Amoco Building  
Roof Replacement  
715 Grantham Lane  
New Castle, DE

Cooperson Project # 16076

Addendum No.2

October 18, 2017

1 RAINWATER CONDUCTOR & SPLASH BLOCK (TYP.)  
 SK-2 SCALE: 1"=1'-0"

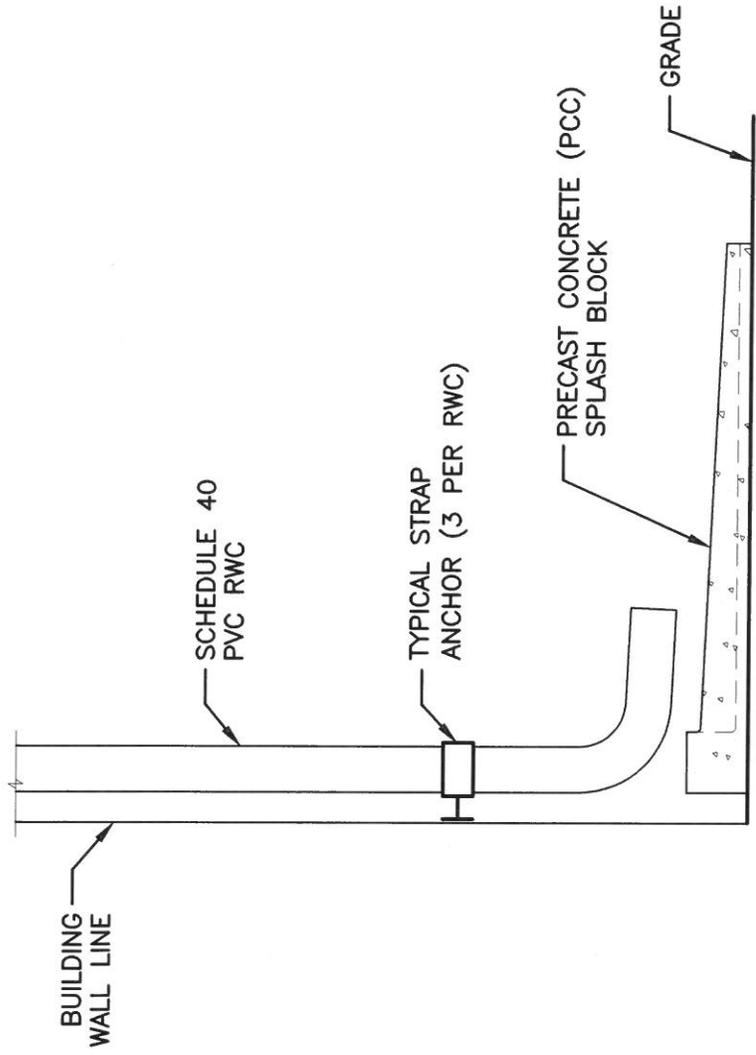
## 2. Rainwater Conductor and Splash Block (Typical Detail)

Drawing No. SK-2, Addendum #2, is attached and is included in this addendum.
